**Project Name:** UNIVERSITY OF CALIFORNIA, MERCED  
LAZY K RESTORATION

**Project No.:** 660175 1B 19900

**ADDENDUM NO. 3**  
to the  
**CONTRACT DOCUMENTS**  
**April 8, 2016**

# SILT FENCE

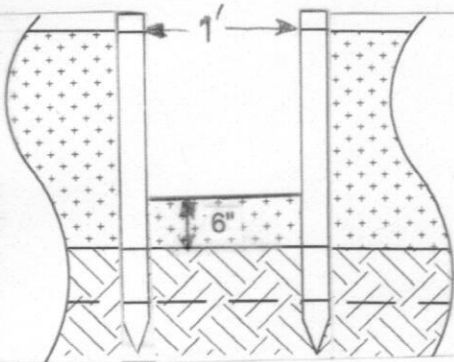
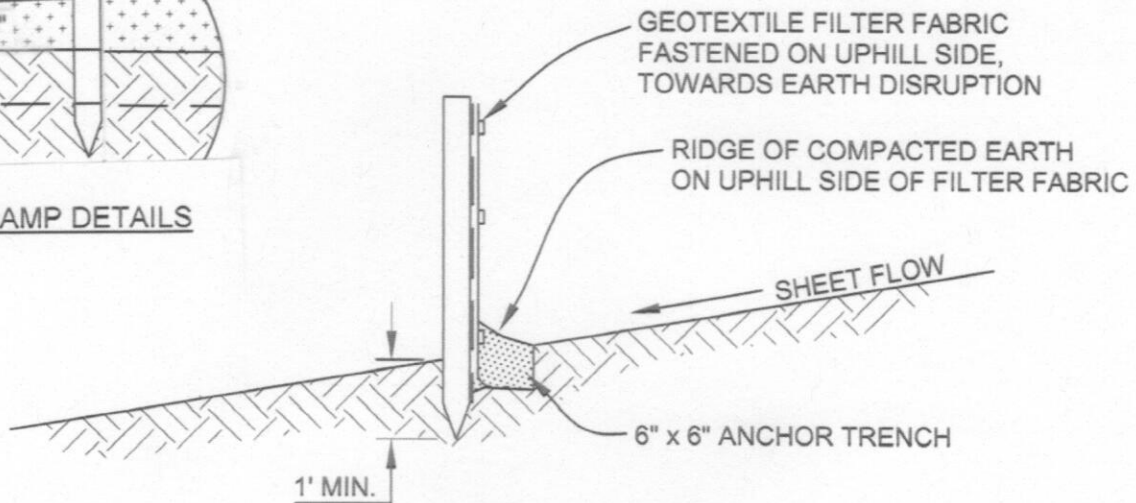
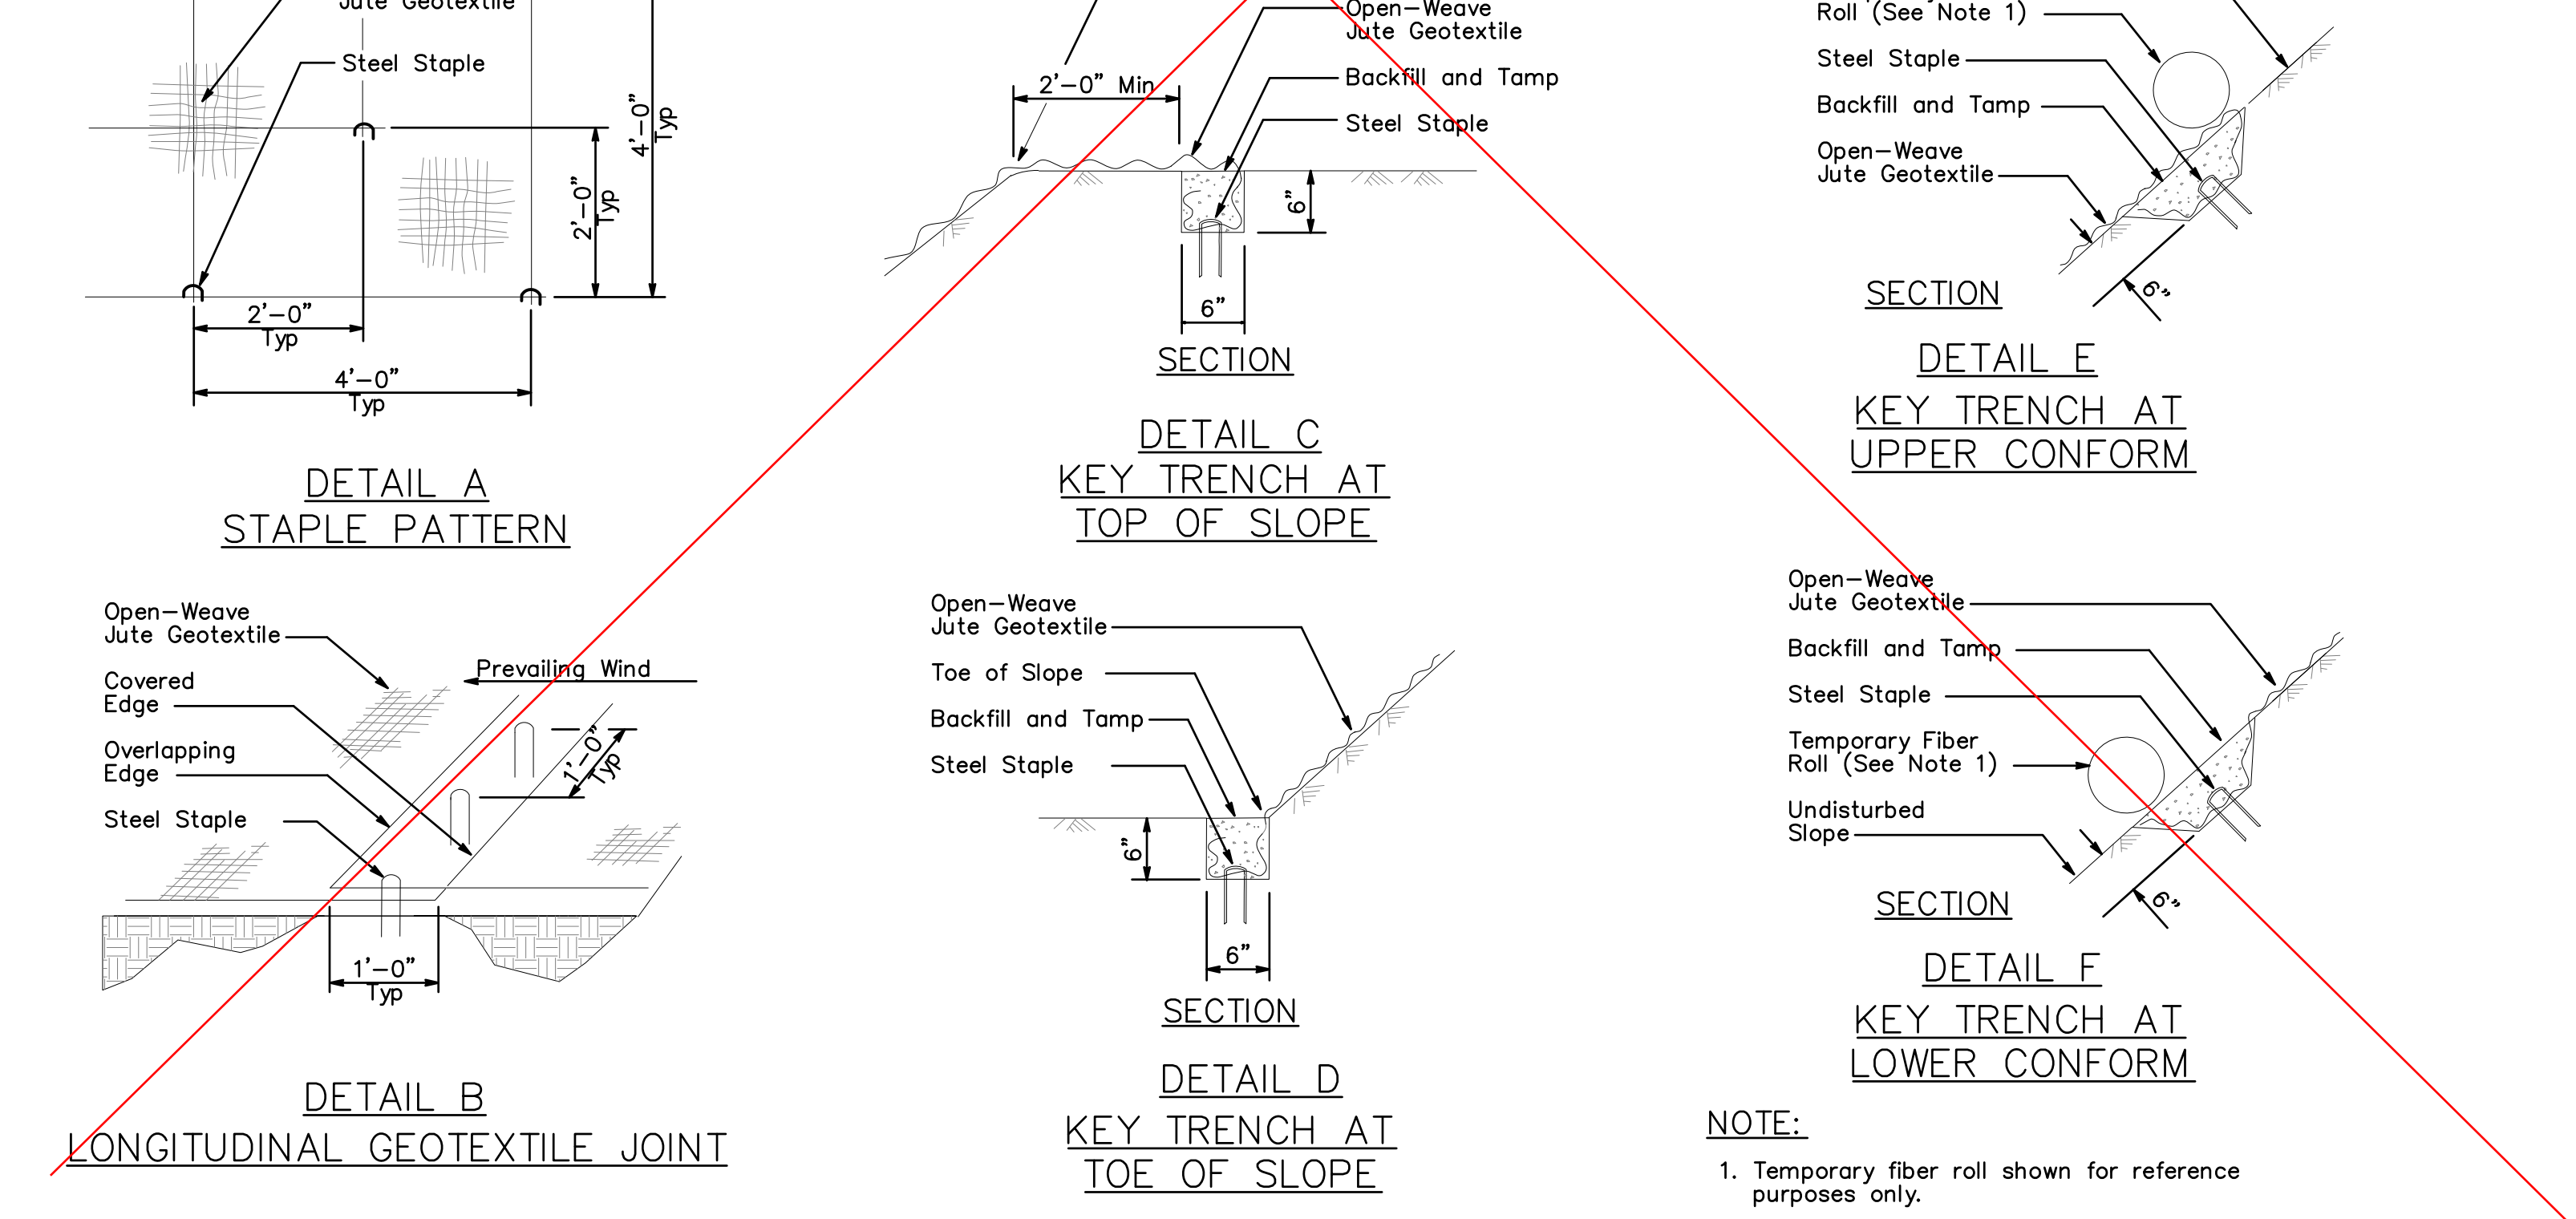
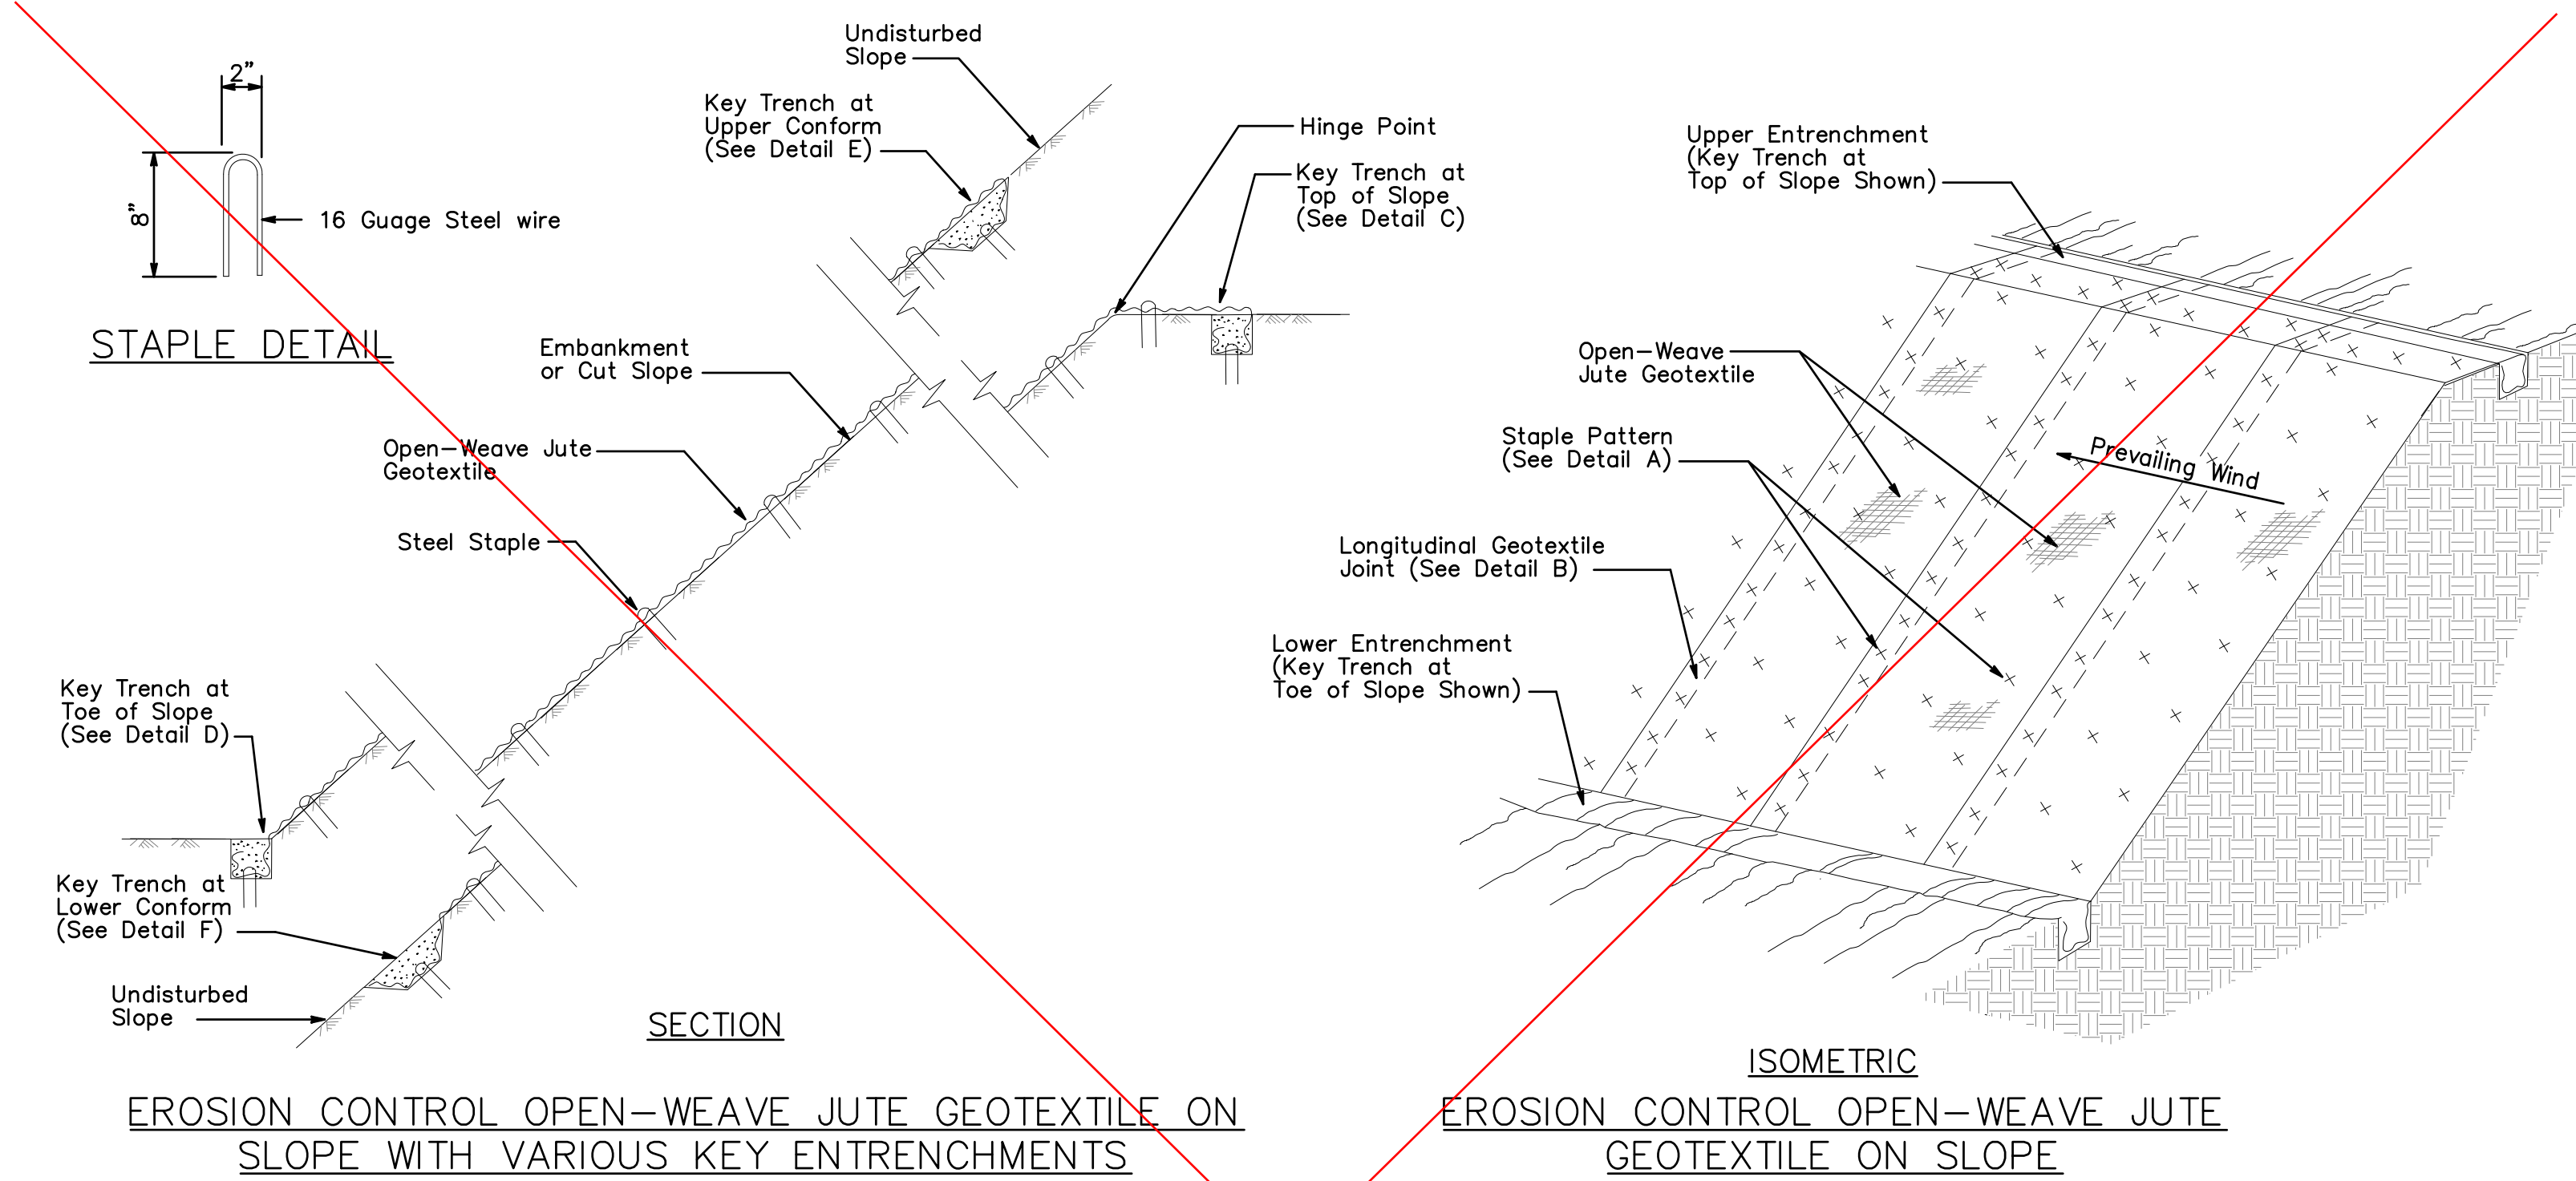
1. Add: CTS Exclusion Silt Fence Installation Specifications for UCM Lazy K I and Lazy K II Preserves, dated March 2016.

- 1) Silt fence material will be standard black silt fencing, 3' width x 100'+ rolls**
- 2) Silt fence to be stapled to 2"x 2" wooden stakes spaced a maximum of 10' along silt fence with specifications shown on design sheet.**

- 3) Base of silt fence to be buried 6 inches below soil surface in an excavated and backfilled trench as shown on design sheet.**
- 4) Roll junctions to be constructed as shown on design sheet.**

- 5) Wildlife ramps to be constructed every 100' along silt fence.**
- 6) Wildlife ramps to be installed on the 'inside' of the silt fence such that they provide escape ramps for wildlife exiting the project construction area.**

- 7) Each wildlife ramp shall be constructed by first constructing a 1' wide opening in the silt fence, bordered on both sides by wooden stakes, and with the silt fencing cut out in the opening to leave 6" of silt fence material extending up from the soil surface, as shown in the bottom drawing of 'Wildlife Ramp Details' on design sheet; and second installing a 1' x 1' square piece of 3/4" plywood in the silt fence opening with the area under the plywood backfilled with compacted soil, as shown in the top drawing of 'Wildlife Ramp Details' on the design sheet.**

Potential Sediment  
Control Requirement Map  
UCM Lazy K Ranch Mitigation Preserve  
Madera County, California

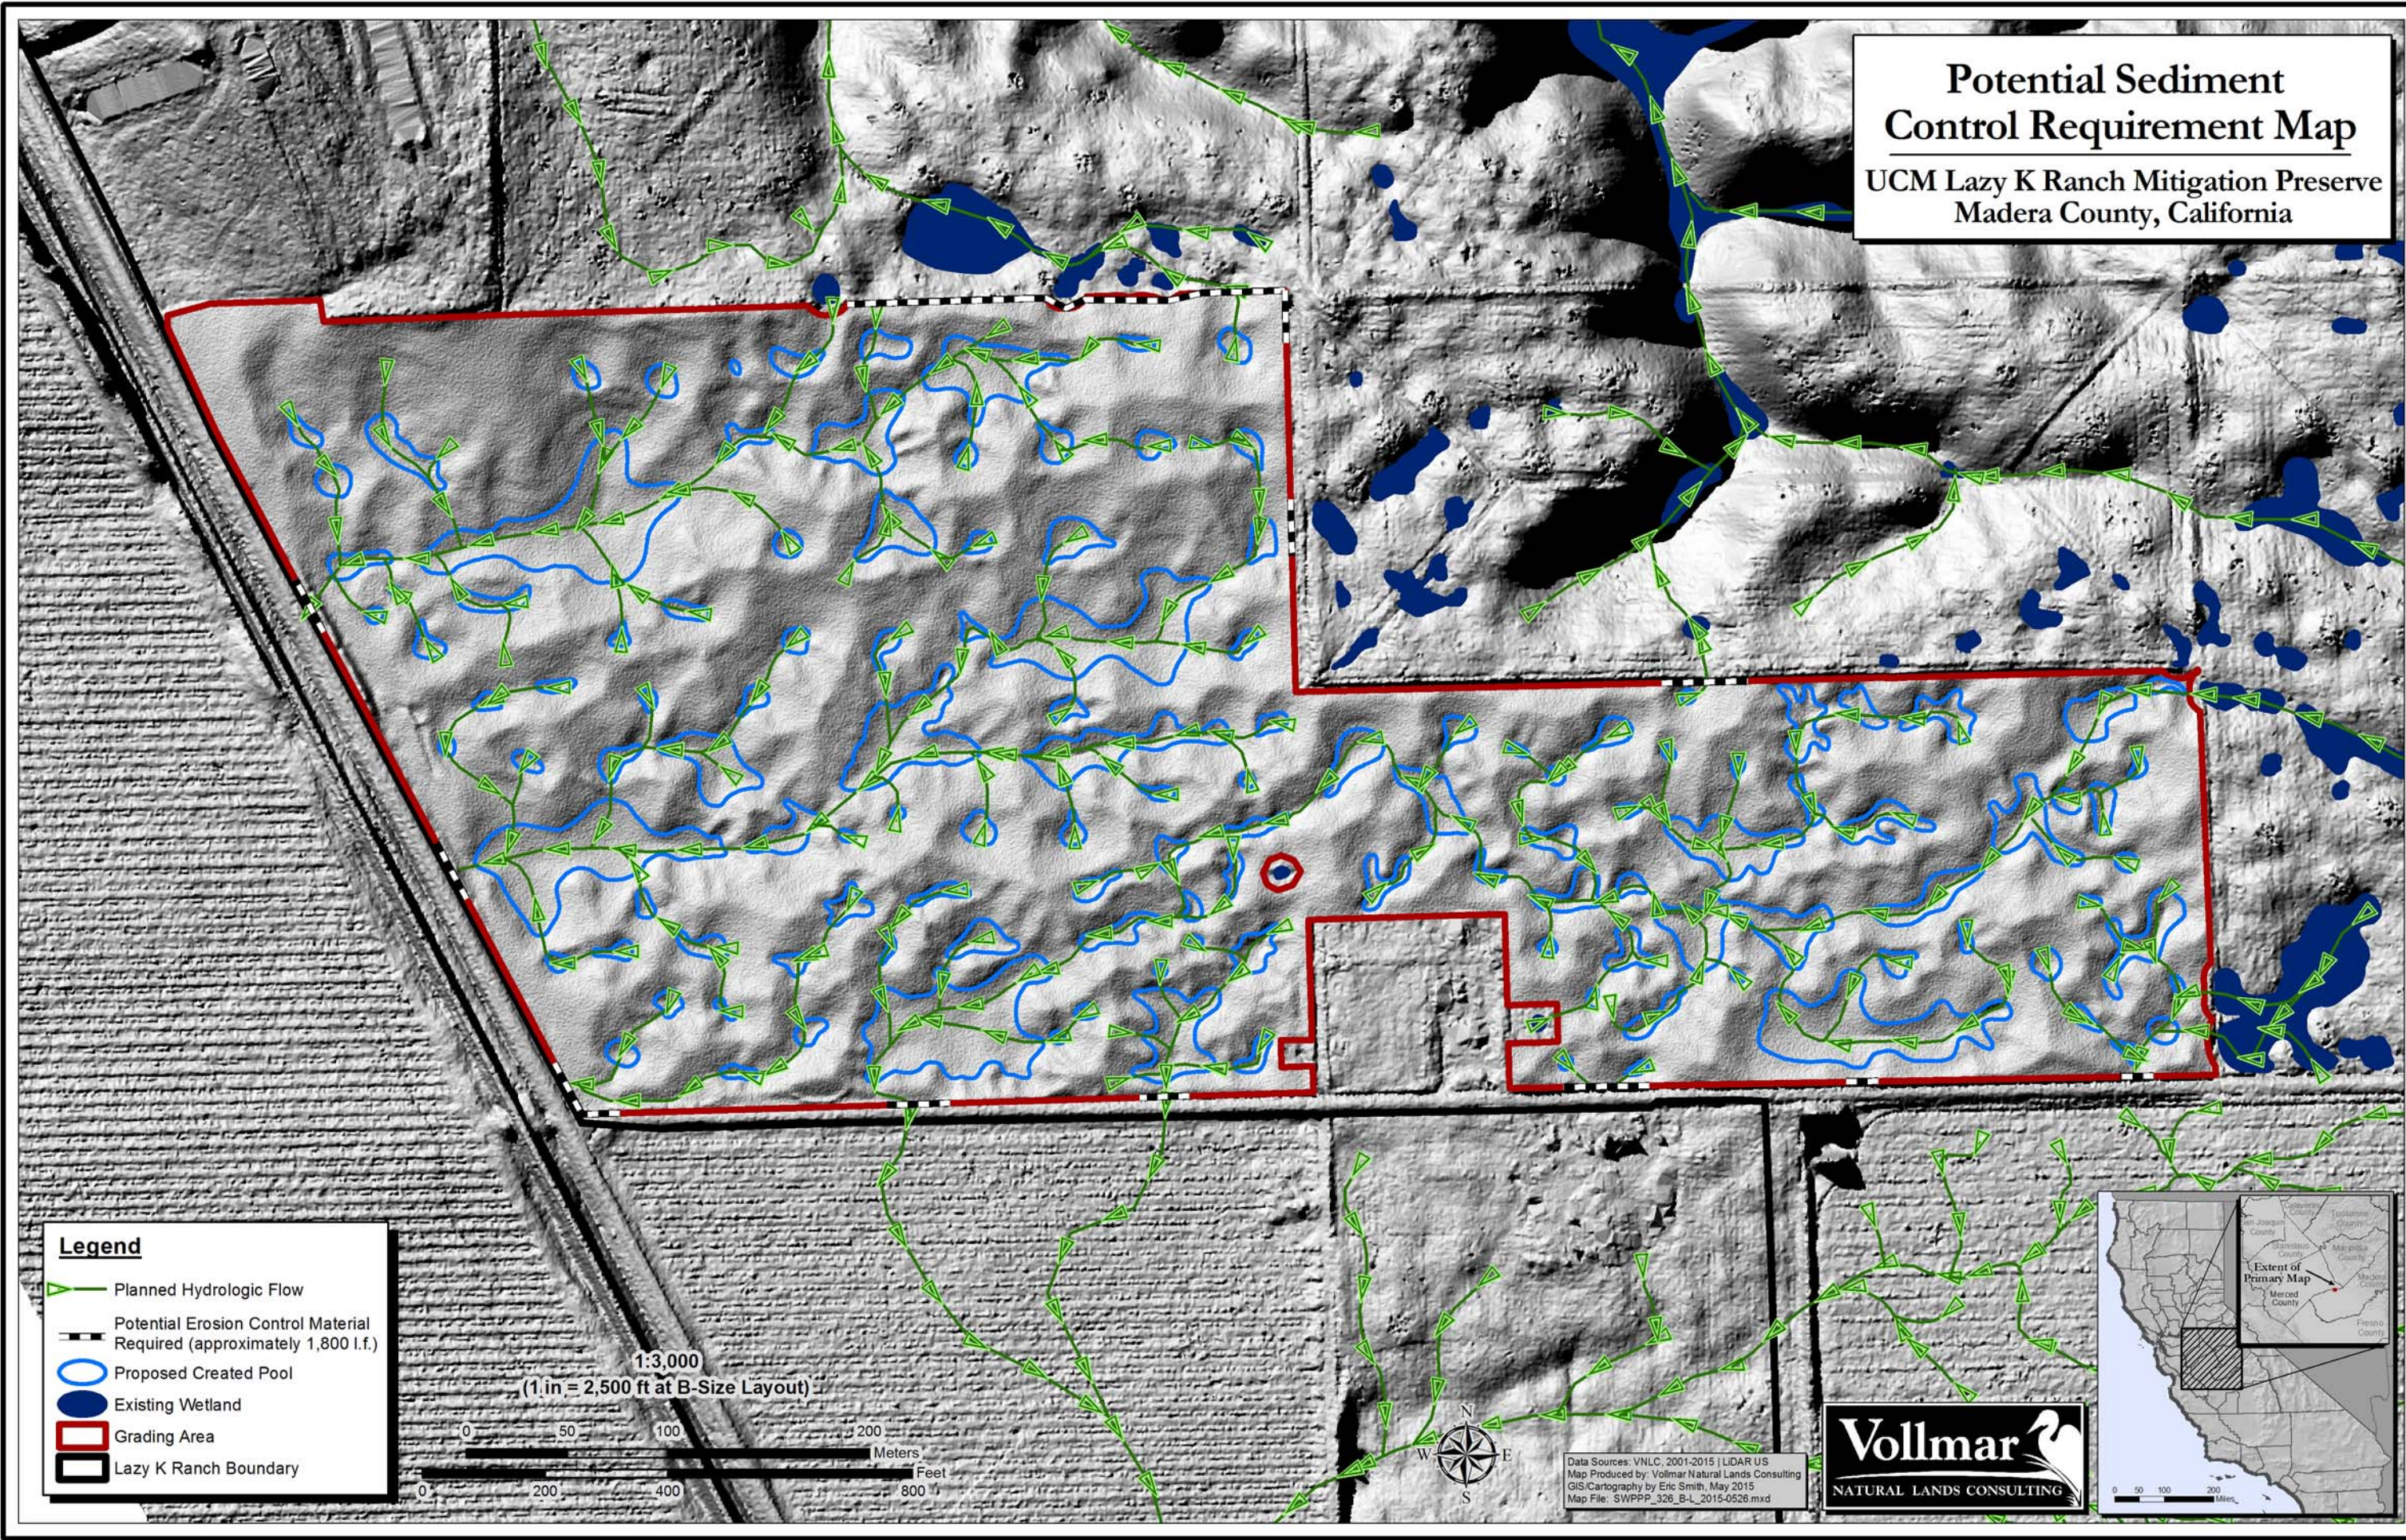
A. Yes in accordance with BMP's and Section 01 57 23.
  6. Q. There is a plan named "Potential Sediment Control Requirement map-SWPPP Erosion Control Plan". Is this the document we are to estimate our costs off?

- A. Investigate and notify University of any presence.
16. Q. Vollmar’s “Potential Sediment Control Requirements Map – Addendum 2 SWPPP Plan, 6/15/2015” shows the sites for “required” sediment control locations, but we were not able to find the SWPPP or any specific information on the BMPs required for these sites. Please provide the information on the materials necessary to complete this task.

A. Yes
  7. Q. It appears Lazy K Ranch I is 65.5 acres based on the report. If you strip the topsoil on the entire site 3-4", the volume is roughly equal to the cut/fill volume of 30,500 CY including or excluding the stripped topsoil?

- A. Specification Section 01 57 23 for BMP and SWPPP requirements.
17. Q. Please provide the approved permit conditions as executed in the state and federal permits and the biological opinions applicable to this project.
